PCN# 20080922000
Datasheet Errata for Device Type TS3DV520E_A
Information Only

PCN Number:	20080922000	PCN Date:	10/13/2008
Title:	Datasheet Errata for Device Type TS3DV520E_A		
Customer Contact:	Linda K Miles	Phone:	903-868-7638
Dept:	Standard Linear and Logic		
Proposed 1st Ship Date:	10/13/2008	Estimated Sample Availability:	10/13/2008
Change Type:			
<input type="checkbox"/>	Assembly Site	<input type="checkbox"/>	Assembly Process
<input type="checkbox"/>	Design	<input checked="" type="checkbox"/>	Electrical Specification
<input type="checkbox"/>	Test Site	<input type="checkbox"/>	Packing/Shipping/Labeling
<input type="checkbox"/>	Wafer Bump Site	<input type="checkbox"/>	Wafer Bump Material
<input type="checkbox"/>	Wafer Fab Site	<input type="checkbox"/>	Wafer Fab Materials
<input type="checkbox"/>		<input type="checkbox"/>	Assembly Materials
<input type="checkbox"/>		<input type="checkbox"/>	Mechanical Specification
<input type="checkbox"/>		<input type="checkbox"/>	Test Process

Texas Instruments' Standard Linear and Logic Group is correcting the datasheet for TS3DV520E; there are several conflicts of spec at the areas of the followings:

Figure 4. r_{on} and V_o vs V_1

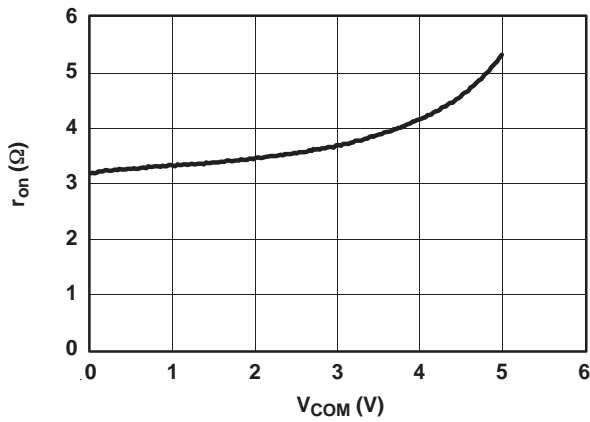
- Operating characteristics graph at the page #6, Figure 4 has to be renamed as "Figure 4. r_{on} vs. V_{com} ($V_{cc}=3.6V$)". And the plot has to be stopped at 3.6V.

Change From

Figure 4. r_{on} V_{com} ($V_{cc}=3.6V$)

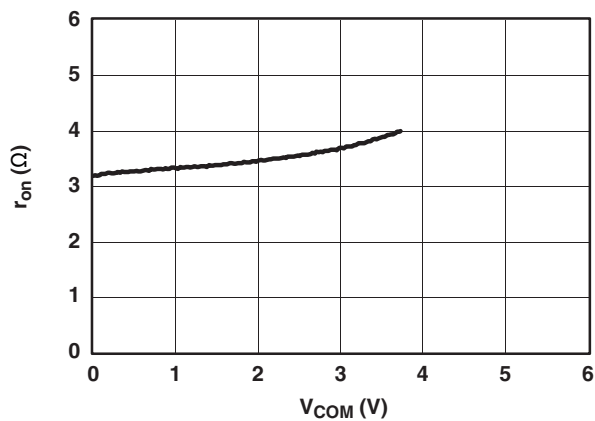
Change To
